COTTAGE GROVE PLANNING COMMISSION

STAFF REPORT CASE: CP/ZA/PUD/PP2024-015

REQUEST: A Comprehensive Plan Amendment, Preliminary Plat, Rezoning, and a Planned Unit Development (PUD) for a project to be known as Preserve at Prairie Dunes that would consist of 162 single-family homes on approximately 60 acres.

Planning Staff Report
Preserve at Prairie Dunes
Planning Case Nos. ZA2024-015, PP2024-015,
PUD2024-015 & CP2024-015
July 22, 2024

PRELIMINARY STREET &
UTILITY PLAN

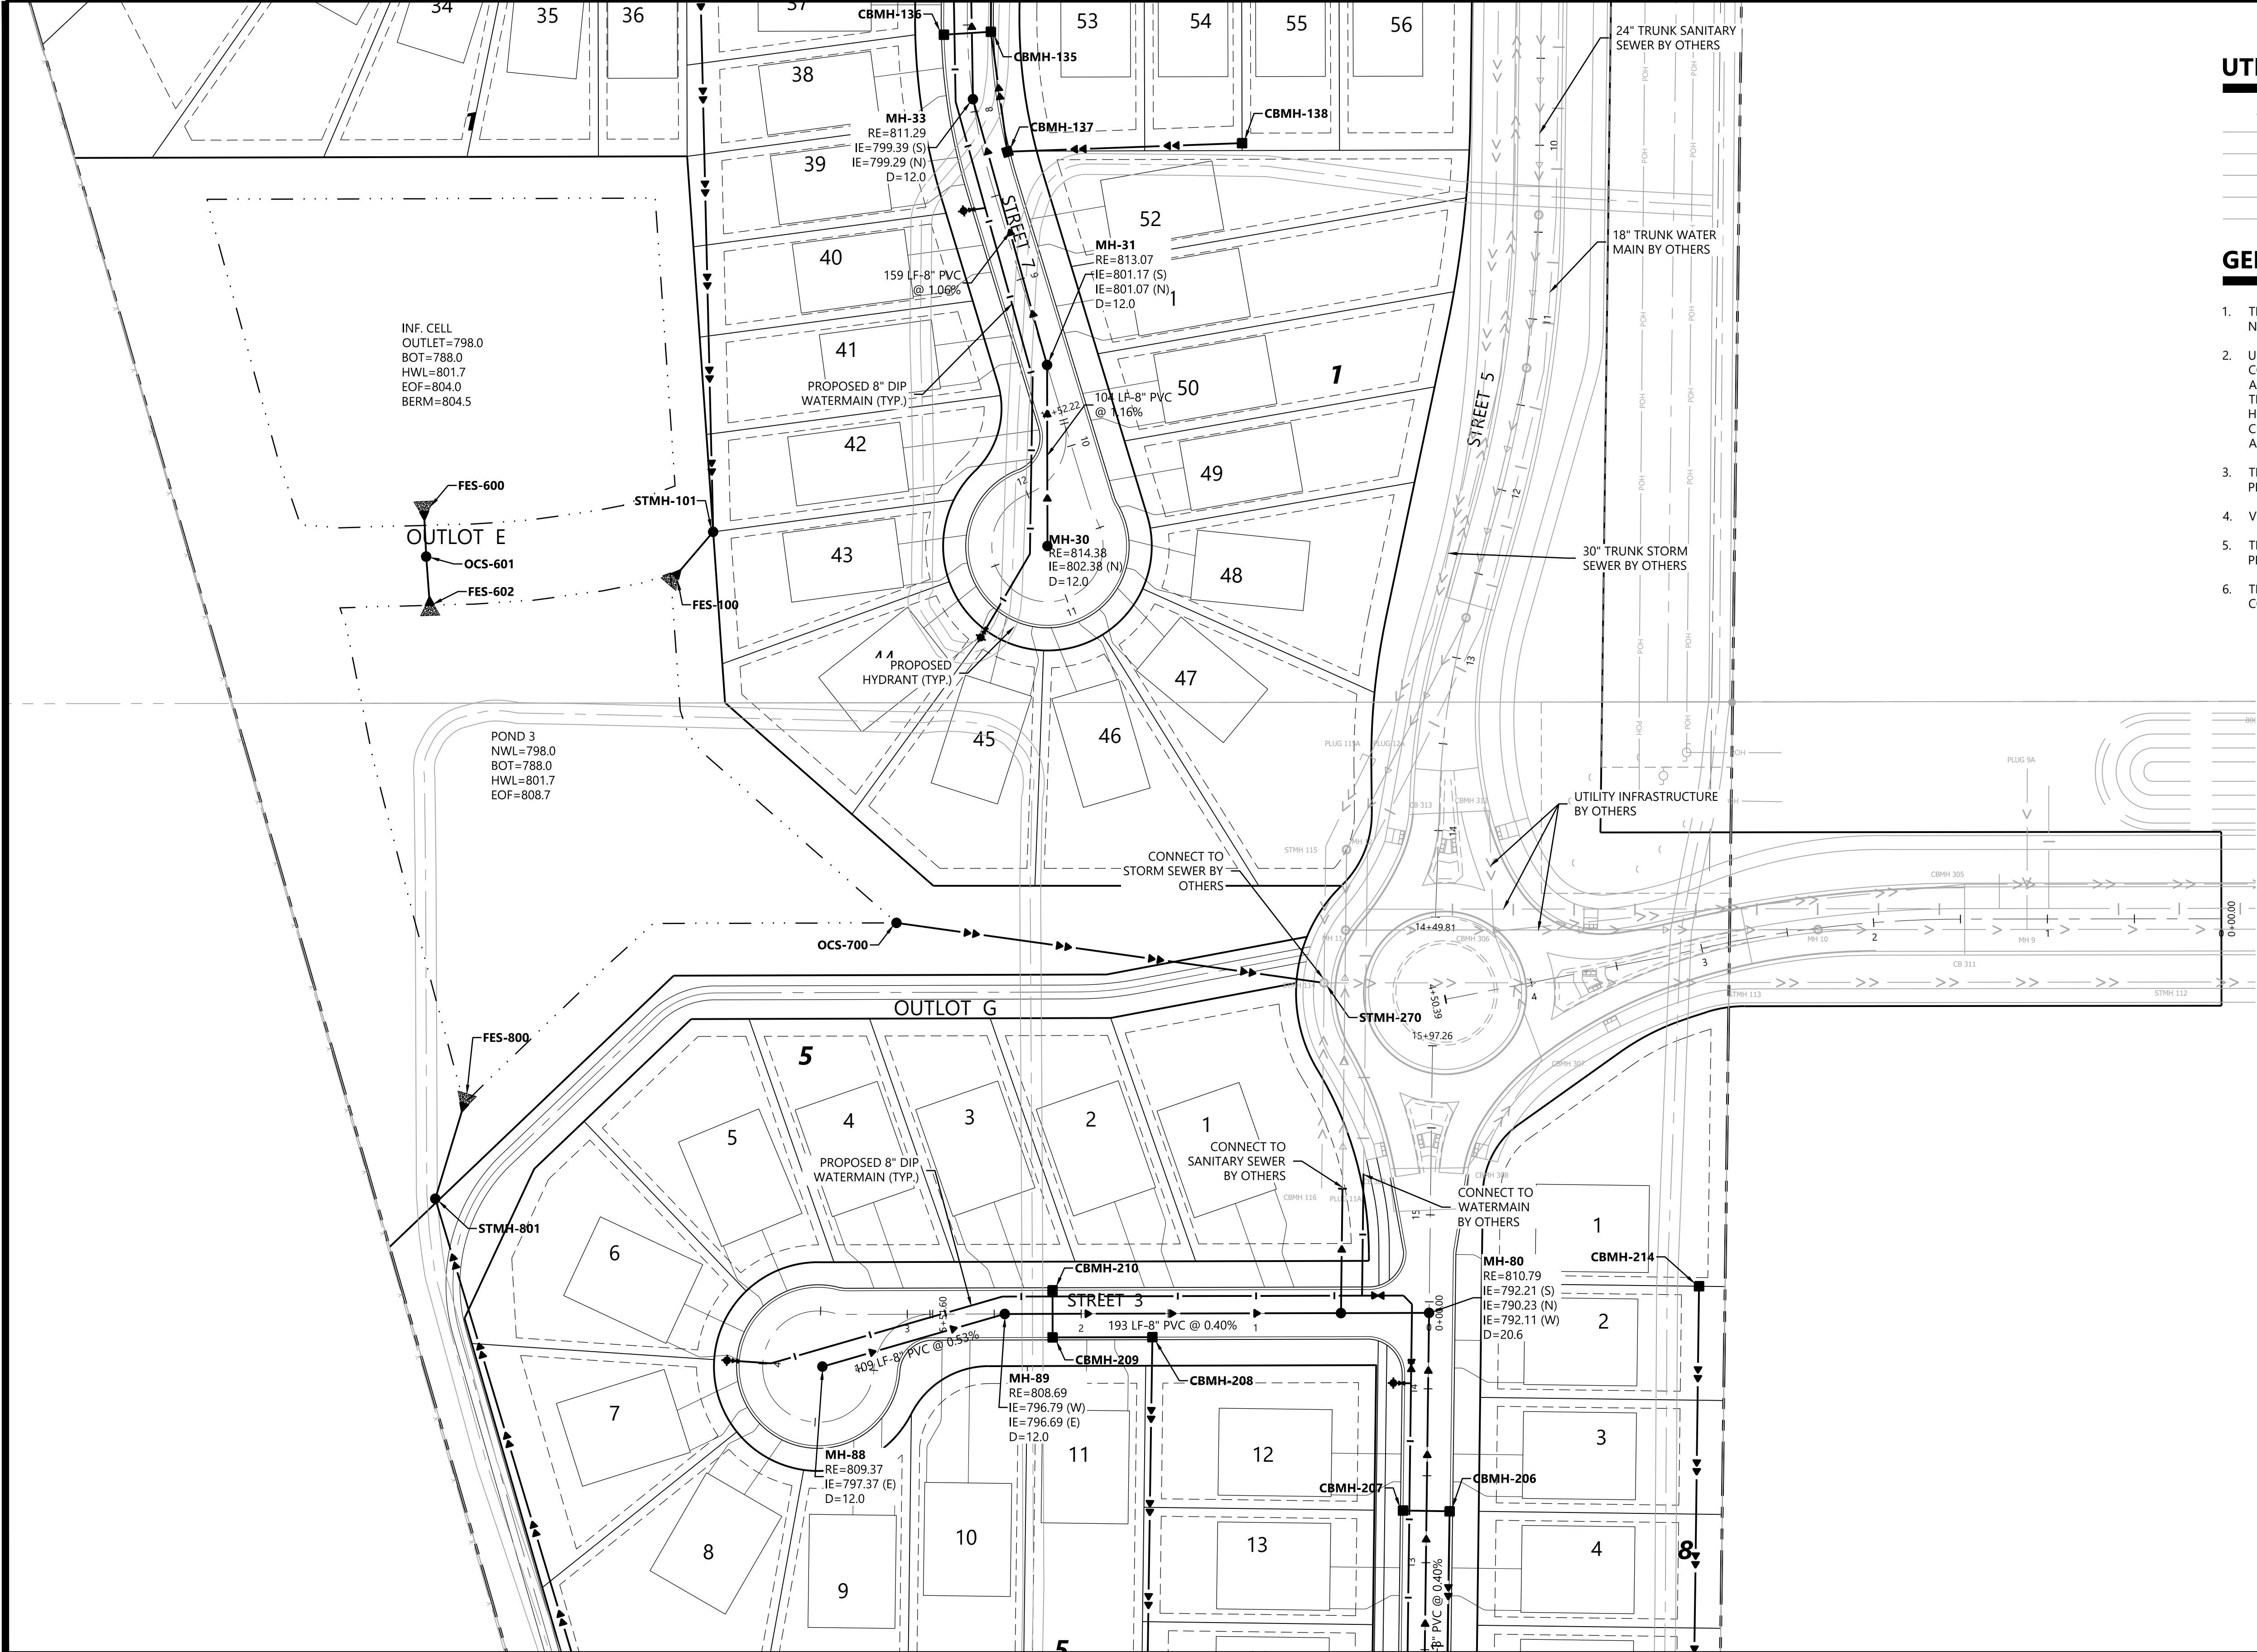
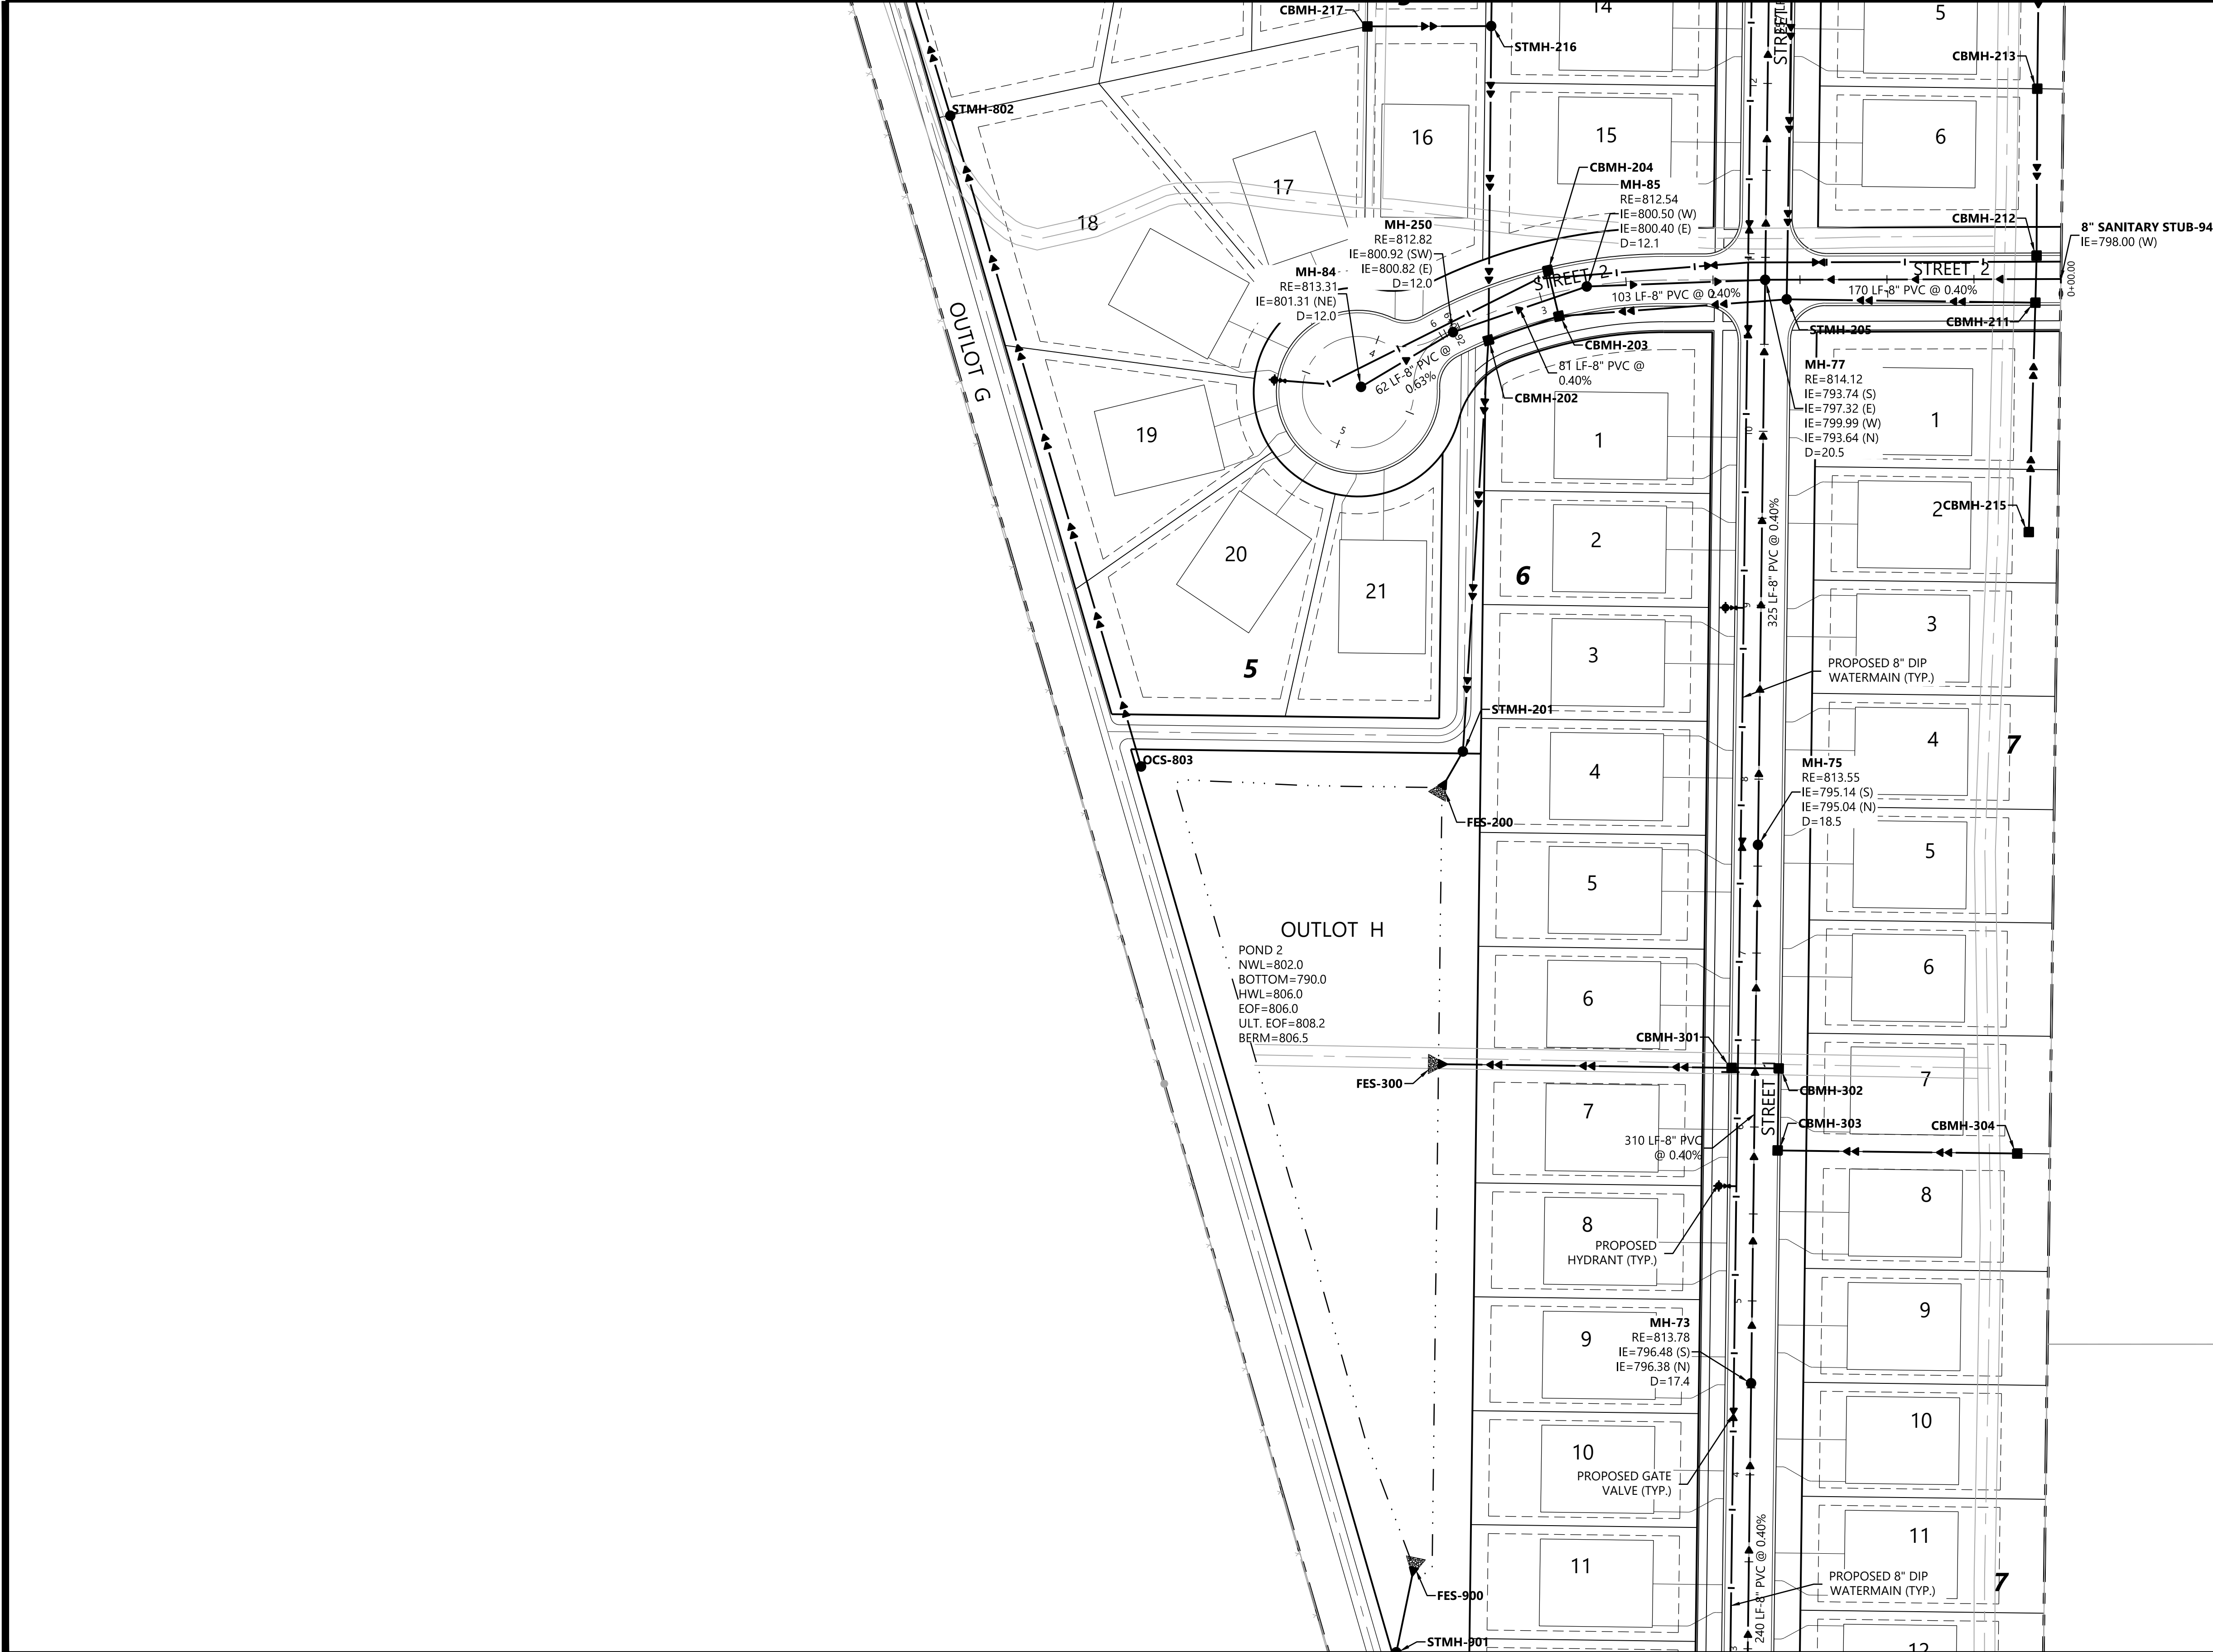
Preliminary Street & Utility Plan Comments (sheets 14 – 23):
